CITY OF ALBUQUERQUE

**RE: Ryan's Sewing & Vacuum
5011 San Mateo Blvd NE
Grading and Drainage Plan
Engineer's Stamp Date: No Date
Hydrology File: F17D103**

Based upon the information provided in your submittal received 02/19/2020, the Grading & Drainage Plan **is not** approved for Building. The following comments need to be addressed for approval of the above referenced project:

PROJECT: RYAN'S SEWING & VACUUM EXPANSION
SHEET TITLE: GRADING AND DRAINAGE PLAN

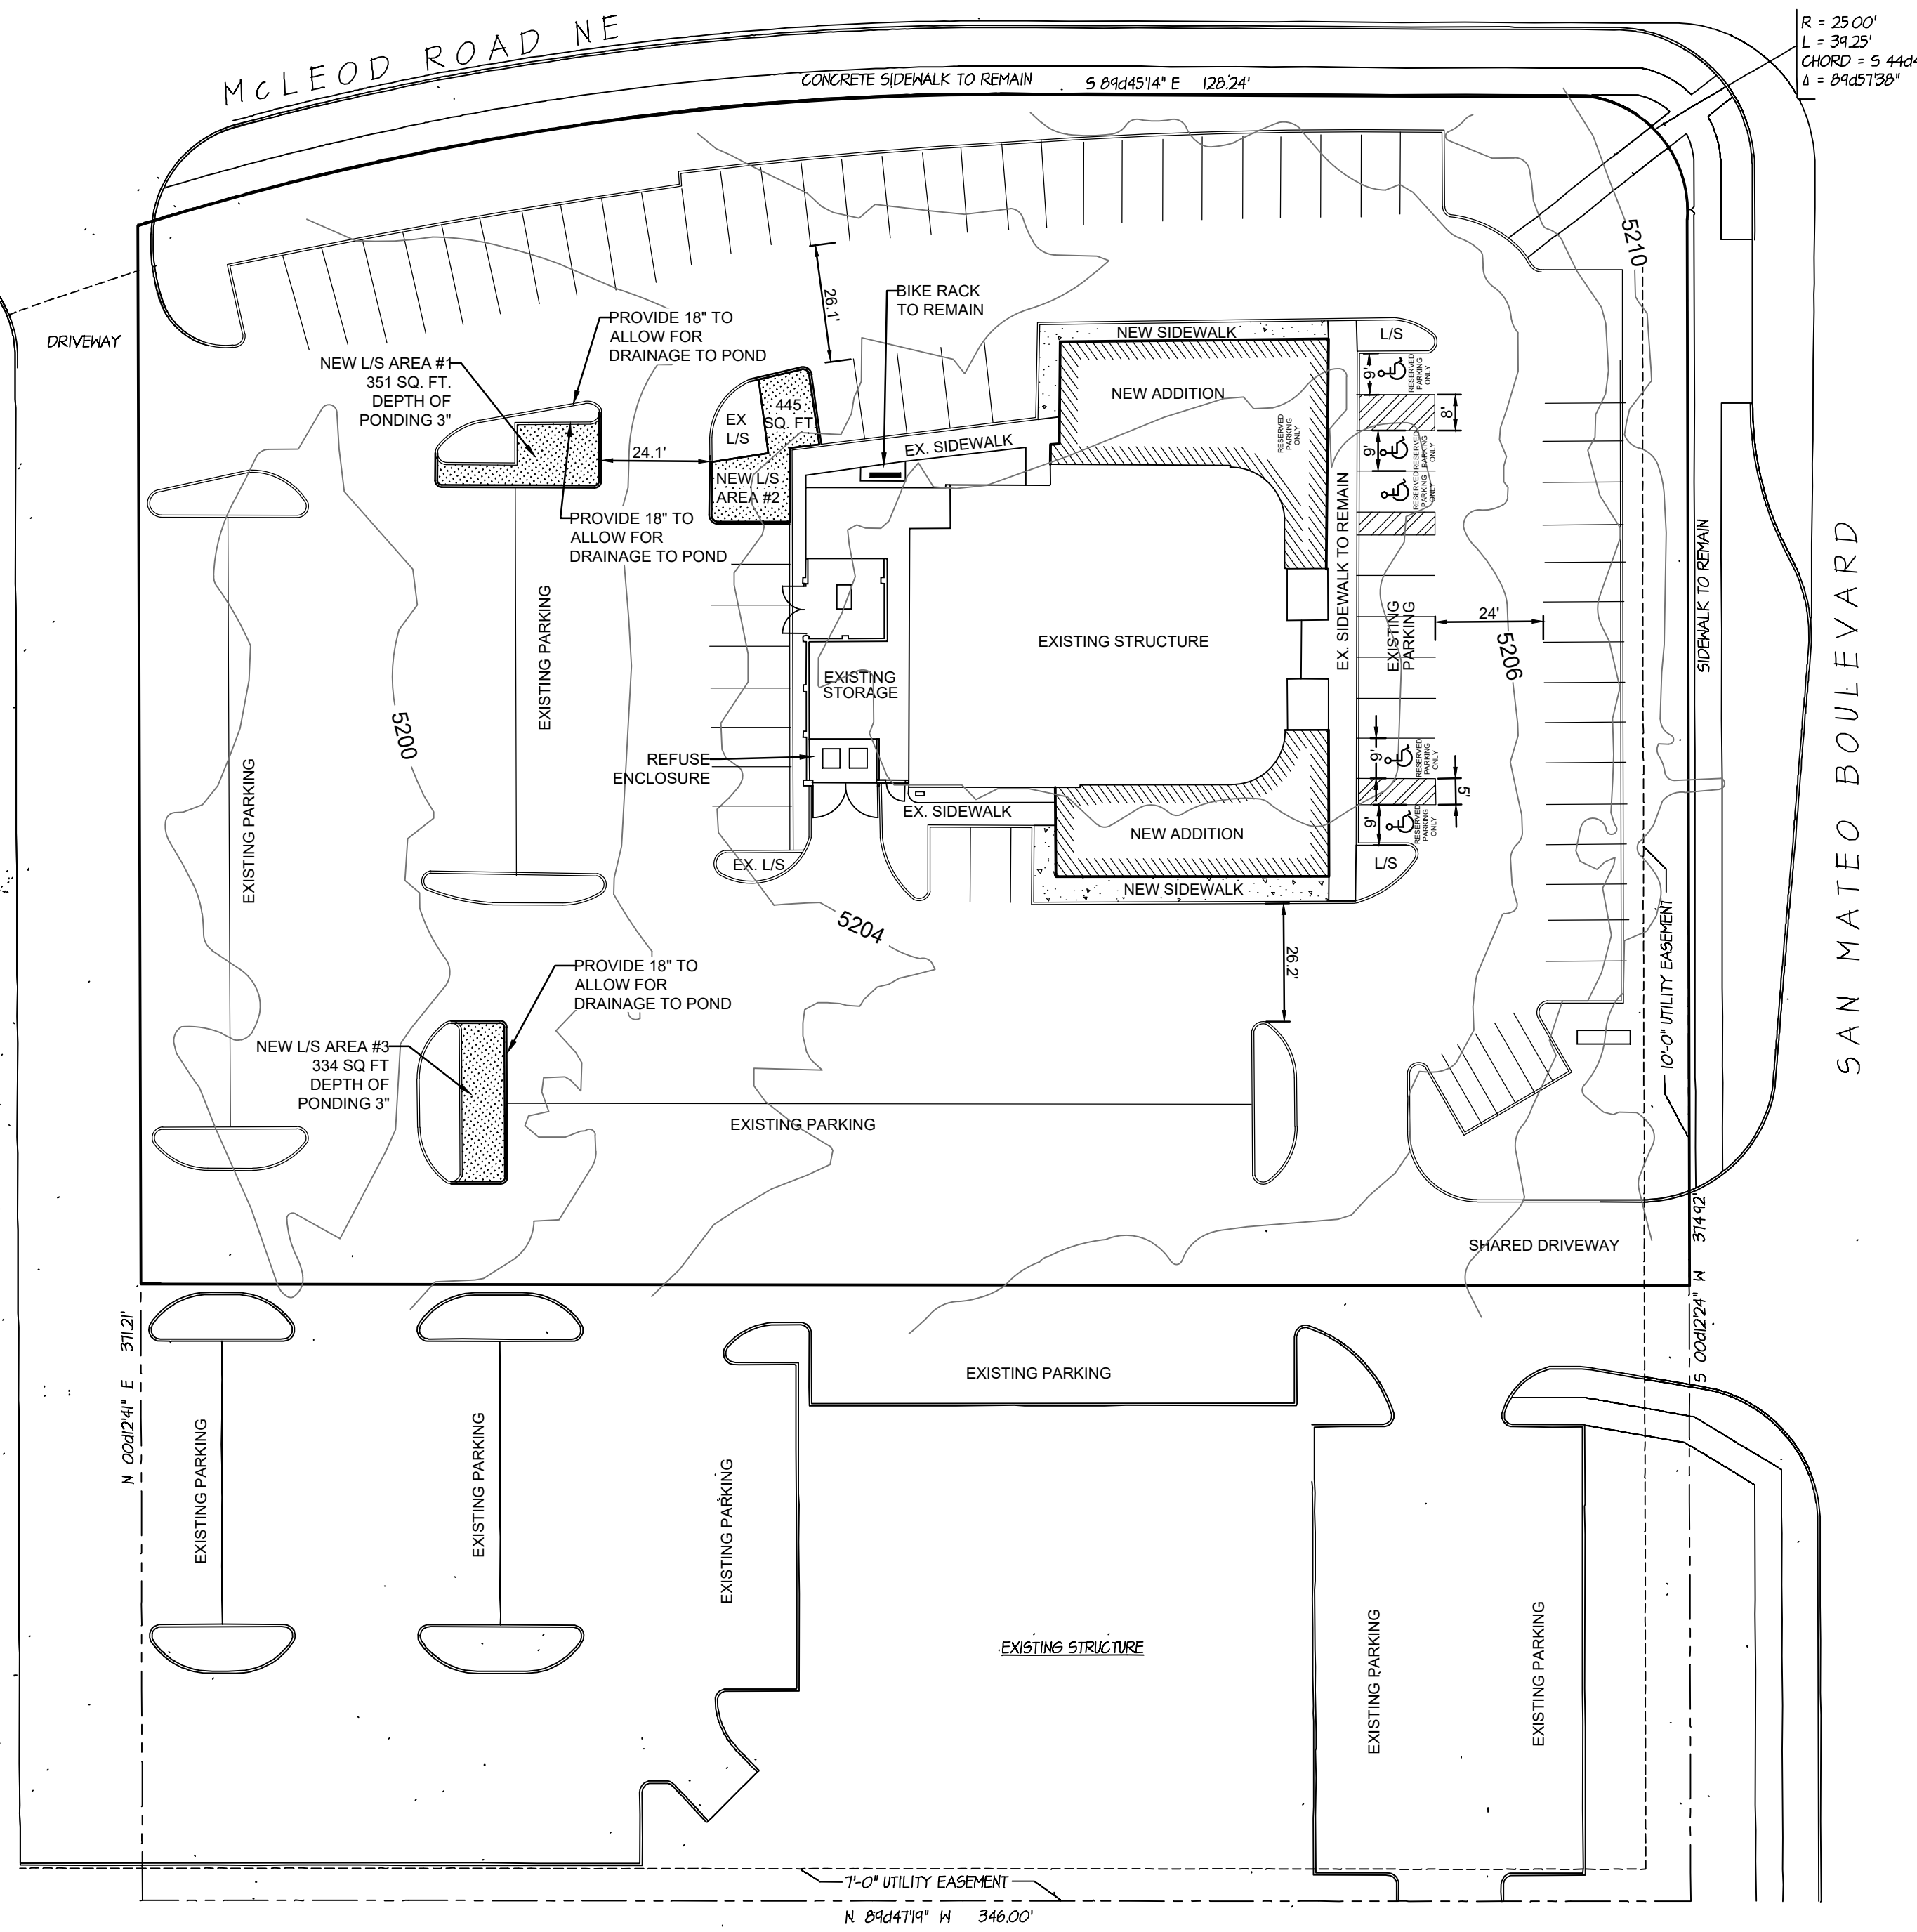
1. Please provide all missing information from the Grading Plan Checklist. **(a, c, d, e, & f)**
Per the DPM Chapter 22 Section 7 - Grading Plan Checklist, the following must be on the Grading Plan. Please add an Engineer's Stamp Date.

- a. Please provide an engineer's stamp with a signature and date.
 - b. Please use 1" = 20' for the scale.
 - c. Please provide a Vicinity Map.
 - d. Please provide the Benchmark information (location, description and elevation) for the survey contour information provided.

- e. Please provide the FIRM Map and flood plain note with effective date.
 - f. Please provide a legal Description of the property.
2. Please use the procedure for 40 acre and smaller basins as outlined in Chapter 22, Part A of the Development Process Manual (DPM). Please provide both the existing conditions and proposed conditions for the 100 year-6 hour storm event. This site is in Precipitation Zone 4. Then you can accurately state if there is an increase, decrease, or the same runoff as the existing conditions.

3. The storm water quality (SWQ) volume for this site is required in order to manage the storm water runoff. Since this is a redevelopment site, the storm water quality volume is calculated based on the 0.48 inch storm. To calculate the required storm water quality volume to be captured, multiply the impervious area by 0.28 inches for the 80th percentile storm. This required storm water quality volume can be captured within the

depressed areas of the landscaping. Please also state the total provided storm water quality volume for the site.

4. Please provide the weir calculations for the curb cuts per the DPM. A coefficient of 2.7 is typically used for the equation (6.60) $Q = CLH^{2/3}$.
5. As a reminder, if the project total area of disturbance (including the staging area and any work within the adjacent Right-of-Way) is 1 acre or more, then an Erosion and Sediment Control (ESC) Plan and Owner's certified Notice of Intent (NOI) is required to be submitted to the Stormwater Quality Engineer (Doug Hughes, PE, jhughes@cabq.gov, 924-3420) 14 days prior to any earth disturbance.
6. Also as a reminder, please provide a Drainage Covenant for the proposed detention ponds per Chapter 17 of the DPM prior to Permanent Release of Occupancy. Please submit this on the 4th floor of Plaza de Sol. A \$25 fee will be required.
7. Standard review fee of \$150 will be required at the time of resubmittal.
